Access Compliance Report

Public Rights-of-Way

(Curb Ramps)

Intersection ID: 27708	Main Street: BREM_LN	Cross Street: LEDERER_AV	Location: NE
ADA ID: C4A509286620	Ramp Type: BlendTrans2	Initial Pass/Fail: Fail	Overall Compliance: No
Severity Score: 8.75			
Codes/Mitigation Info/Possible Solution		Field Measurements/Component Compliance

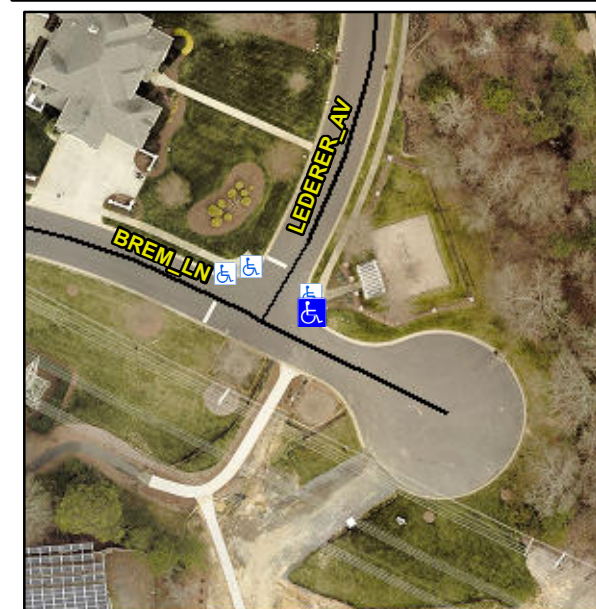
Not Found, R304.5.1

Compliance	Description	Data	Compliance	Description	Data
N/A	Ramp Length (in)	89.0	Yes	BlendTrans Slope (%)	2.5
No	Ramp Width (in)	43.0	Yes	BlendTrans XSlope (%)	0.5
N/A	Flare Type LT	N/A	N/A	Flare Type RT	N/A
N/A	Flare Slope LT (%)	N/A	N/A	Flare Slope RT (%)	N/A
N/A	Flare Traversable LT?	N/A	N/A	Flare Traversable RT?	N/A
N/A	Landing Length (in)	N/A	N/A	DWS Provided?	N/A
N/A	Landing Width (in)	N/A	N/A	DWS Contrast?	N/A
N/A	Landing Slope (%)	N/A	N/A	DWS Length (in)	N/A
N/A	Landing X Slope (%)	N/A	N/A	DWS Full Width?	N/A
N/A	Landing Curb? (Y/N)	N/A	N/A	DWS Offset (in)	N/A
N/A	Shared Landing?	N/A			
N/A	Gutter Ponding?	N/A	N/A	Gutter Slope (%)	N/A
N/A	Gutter Lip Ht (in)	N/A	N/A	Gutter X Slope (%)	N/A
N/A	Painted X Walk1?	No	N/A	Painted X Walk2?	N/A
	X Walk 1 Direction	To SW		X Walk 2 Direction	N/A
	X Walk 1 Width (in)	N/A		X Walk 2 Width (in)	N/A
	X Walk 1 Slope (%)	3.8		X Walk 2 Slope (%)	N/A
	X Walk 1 X Slope (%)	3.7		X Walk 2 X Slope (%)	N/A

N/A	Ramp inside XWalk1?	N/A	N/A	Ramp inside XWalk2?	N/A
	Road Slope (%)	3.7		Clear Space?	N/A
	Road X Slope (%)	3.8	N/A	Clear Space to XWalk (in)	N/A
N/A	Any Obstructions?	N/A	N/A	Storm Grate/Utility Hazard?	N/A
	Obstruction Type			Storm Grate/Utility Type	
		N/A			N/A
			Yes	Surface Condition? (G/P)	Good
			No	Curb Slope (%)	17.3

Remove & Replace Curb Ramp With Two New Directional Ramps or Equivalent.
